**Bayside Planning Panel**

Item No	<b>6.2</b>
Application Type	Development Application
Application Number	DA-2016/150
Lodgement Date	22 October 2015
Property	<b>401-405 Princes Highway, Rockdale</b>
Owner	Mr & Mrs Ibrahim & Ibrahim Pastry Pty Ltd
Applicant	Architecture & Building Works Pty Ltd
Proposal	Integrated Development - Construction of a seven (7) storey mixed use development comprising 39 residential units, two (2) commercial units and four (4) levels of basement parking
No. of Submissions	One (1)
Cost of Development	\$13,103,720
Report by	Fiona Prodromou – Senior Assessment Planner

## Planning Assessment Report

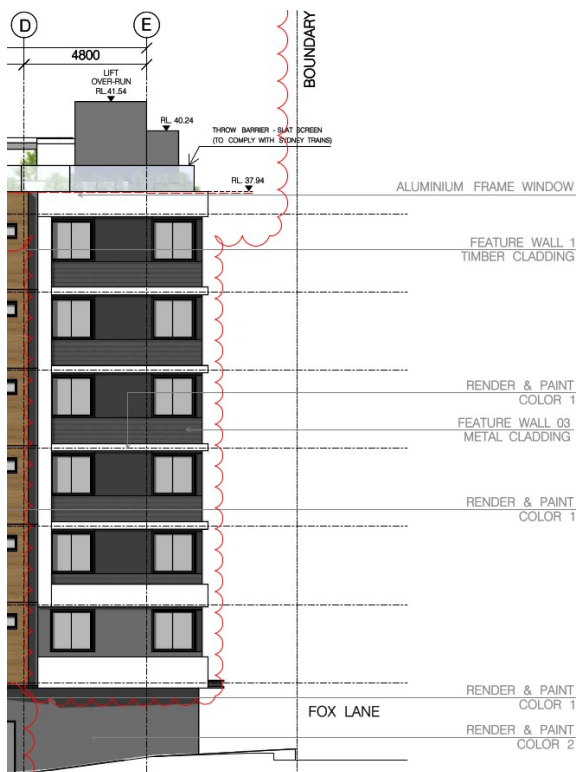
The proposed development is required to provide a 3 storey podium setback 3m from the Princes Highway frontage of the site, in order to accommodate the envisaged 'Green Gateway' corridor.

Additionally, levels 4 and above are to be recessed an additional 3m from the podium below, with a side setback of 4.5m at level 4 and above with a minimum building separation distance of 9m to neighbouring buildings.

The proposal provides a 3 storey podium, recessed 3m from the front property boundary, with levels 4 and above recessed a further 3m as required by this clause.

Level 4 and above is setback 4.5m from the northern common side boundary of the site as required by the provisions of this clause.

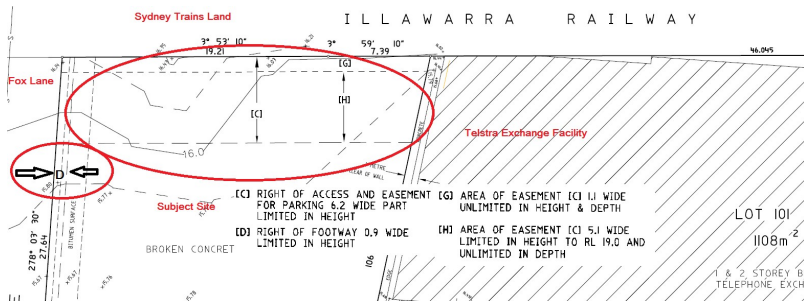
Comment: Fox Lane comprises a variable width of 5.825m at the western end and 6.1m at the eastern end at the junction with the Princes Highway. Plans do not seek to widen the existing lane width as suggested by the DRP. Plans illustrate a 3m building setback at ground level to Fox Lane, with an associated pedestrian pathway and landscaping proposed, all within the property boundaries of the subject site. Proposed finishes, levels and specifications of any kerb / gutter and any associated stormwater works likely to be required within Fox Lane have not been submitted for assessment. The entire length of the southern boundary of the site is burdened by Telstra easements for drainage and a right of footway which benefits Bayside Council. As such the current design conflicts with these easements.

Plans further illustrate that the proposed building form beyond the Fox Lane lift core, maintains a breach to the height standard as can be identified in yellow and illustrated in the southern elevation below. This is contrary to the comments of the Design Review Panel and is not supported. Further, units 8.4 and 9.4 have not been deleted as suggested by the DRP. Revised plans illustrate the provision of the required 3m building setback from the front property boundary, with basement levels below also setback 3m from this front boundary, in order to facilitate Councils Princes Highway Green Gateway Vision and enable the planting of trees in deep soil on site.

The DRP noted that *'there is insufficient information to understand the constraints arising from the various easements on the site. Full documentation and sign off by Telstra is required.'*

#### 4.7 Waste Storage and Recycling Facilities

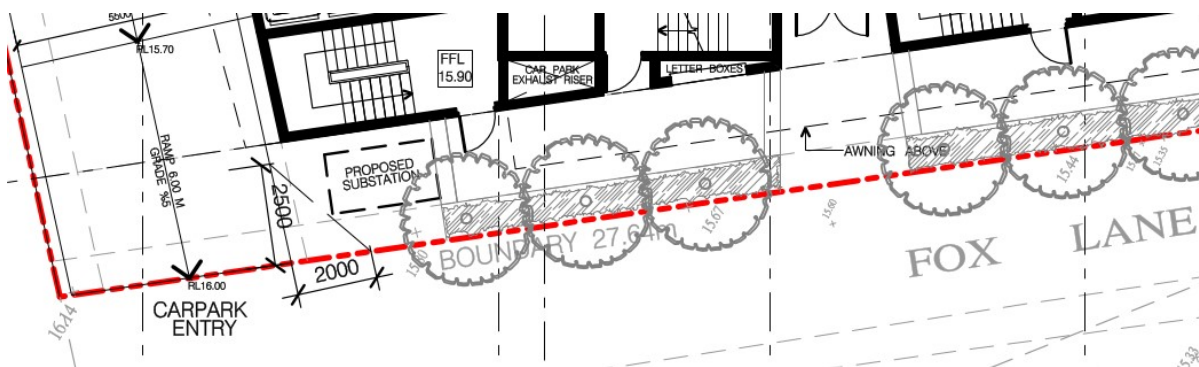
Plans indicate the provision of waste chutes within the development, adjoining each lift core within the building. Waste is to be discharged into 1100 litre bins within the waste storage rooms at ground level within the development. A separate waste storage room is provided for the commercial component of the development.

Waste storage rooms are of sufficient dimensions and area to accommodate the proposed development. The proposal provides for appropriate on site waste management and

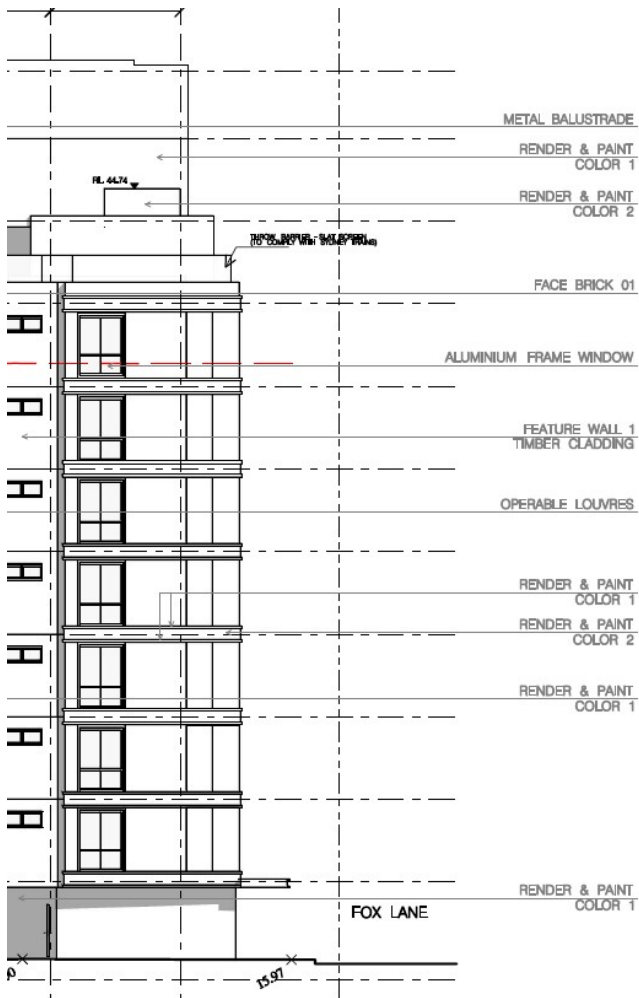
The proposed development is required to provide a 3 storey podium setback 3m from the Princes Highway frontage of the site, in order to accommodate the envisaged 'Green Gateway' corridor.

Additionally, levels 4 and above are to be recessed an additional 3m from the podium below, with a side setback of 4.5m at level 4 and above with a minimum building separation distance of 9m to neighbouring buildings.

The proposal provides a 3 storey podium, recessed 3m from the front property boundary, with levels 4 and above recessed a further 3m as required by this clause.

Level 4 and above is setback 4.5m from the northern common side boundary of the site as required by the provisions of this clause.
